SERVICE BULLETIN NO: NMD-52-9

TITLE: Doors - Crew Door Modifications and Additional Signs and Markings required for Transport Category Operation (Mod N240 or N240-24)

DOORS, CREW DOOR MODIFICATIONS AND ADDITIONAL SIGNS  
AND MARKINGS REQUIRED FOR TRANSPORT CATEGORY OPERATION  
(MODIFICATION N240 OR N240-24)

Crew Door Modifications and Fitting of EXIT Signs

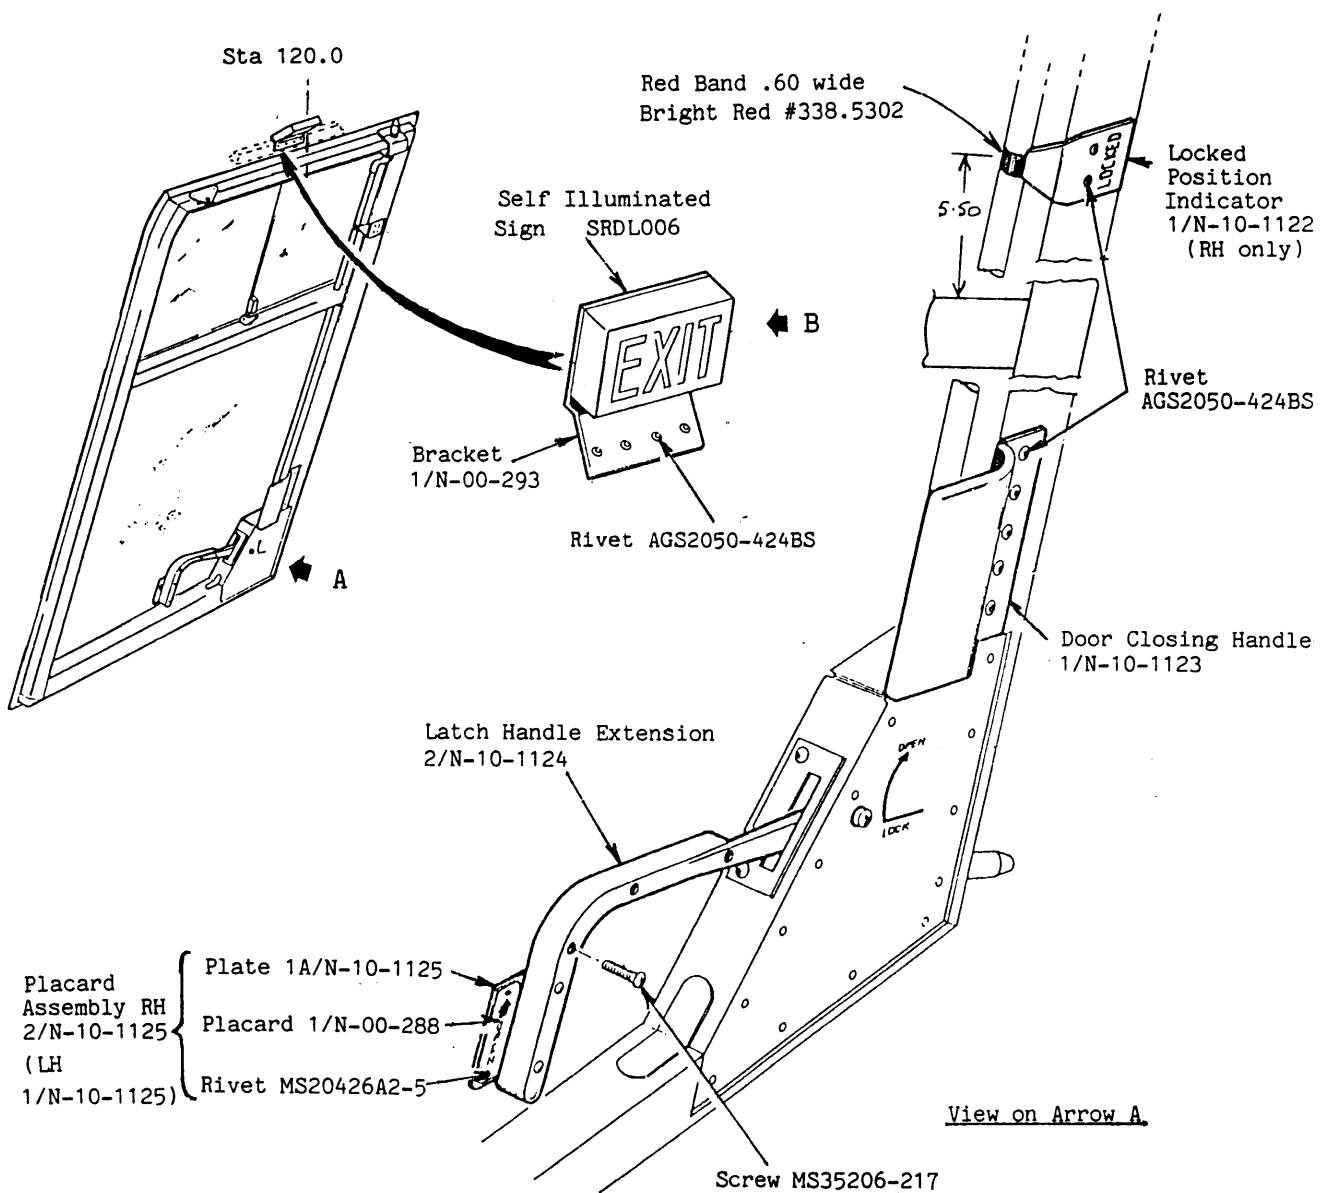
Door closing handles and latch handle extensions are added to the crew doors. A door closed indicator is added to the RH crew door. Self illuminating exit signs are added above each crew door and an exit sign is painted on the rear face of Sta 132.00. For N24 Series aircraft, various external placards are revised.

- A. On the RH crew door, position the door closing handle 1/N-10-1123 as shown in Figure 1. With the door closing handle as a template and using a No. 30 drill, drill five holes in the door frame. Deburr the holes and rivet the handle to the door frame with five AGS 2050-424BS rivets.
- B. Repeat A for the LH crew door.
- C. Close and lock the RH crew door. Position the locked position indicator 1/N-10-1122. (refer Figure 1). With the locked position indicator as a template, and using a No. 30 drill, drill two holes in the door frame. Deburr the holes and rivet the locked position indicator to the door frame with two AGS 2050-424BS rivets.

D. Position the latch handle extension 2/N-10-1124 on the RH crew door latch handle and mark the position for the three holes. Using a 3 mm drill, drill the three holes as marked in the latch handle. Deburr the holes. Attach placard assembly RH 2/N-10-1125 (LH 1/N-10-1125) to the latch handle extension with three MS 24693S5 screws and attach the latch handle extension to the latch handle with three MS35206-217 screws.

F. Using a No 5 drill, drill two holes in the brackets 1/N-00-293 to suit the self illuminating exit signs SRDL006. Apply a strip of double sided tape 4032 to the brackets as shown in Figure 1 and mount the exit signs to the brackets using washers AN960PD10, spring washers MS35338-43 and nuts MS35650-302.

G. Position the exit sign and bracket above the RH crew door centered about Sta 120.0 as shown in Figure 1. With the bracket as a template, and using a No. 30 drill, drill four holes in the door frame structure. Deburr the holes and rivet the bracket in position with four AGS 2050-424BS rivets.

K. Close and lock the RH crew door. Using bright red paint colour No. 338.5302, paint the latch handle extension on the RH and the LH crew door and a .60 in wide band on the door locking tube for the RH crew door as shown in Figure 1.

Figure 2

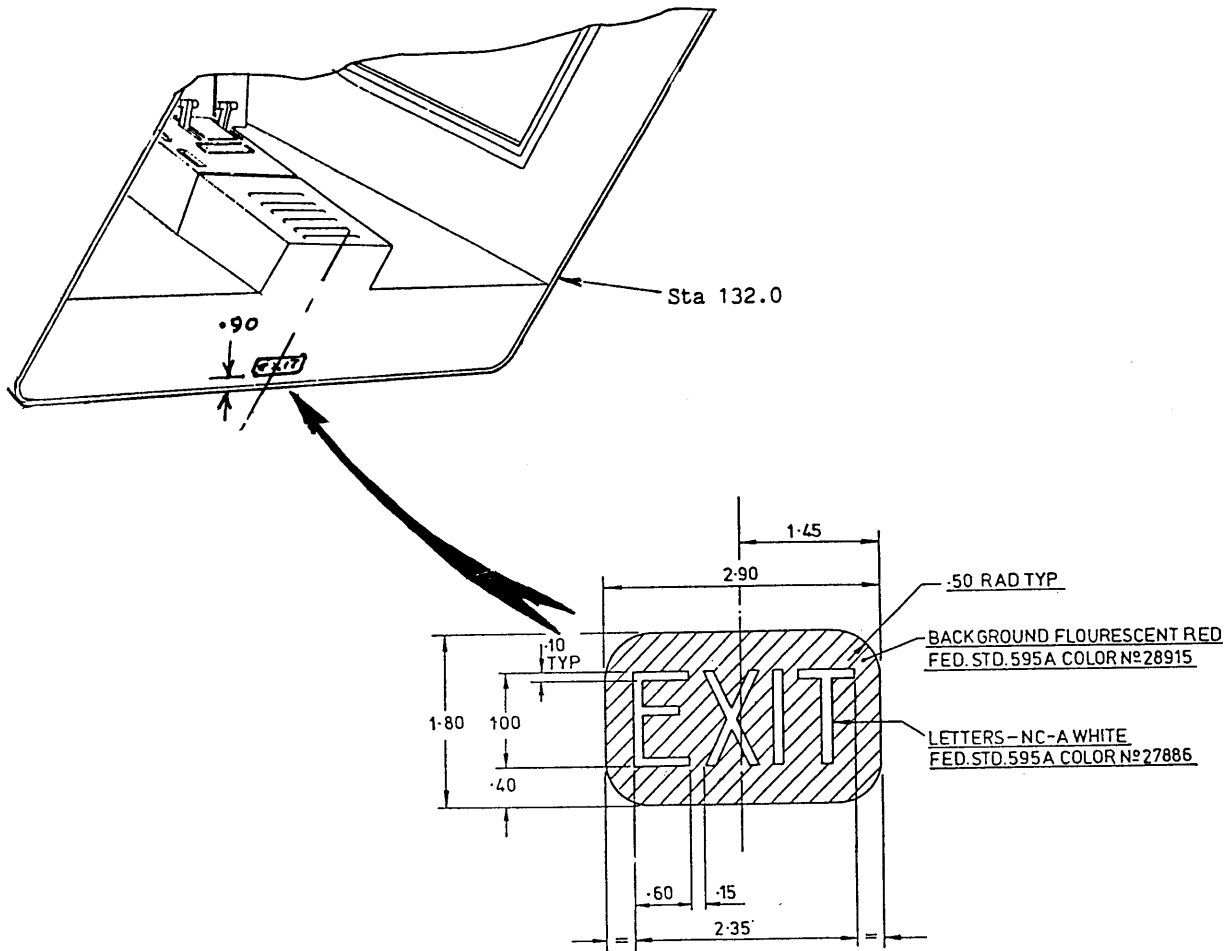
L. Paint an exit sign on the rear face of Sta 132.00 as shown in Figure 2.
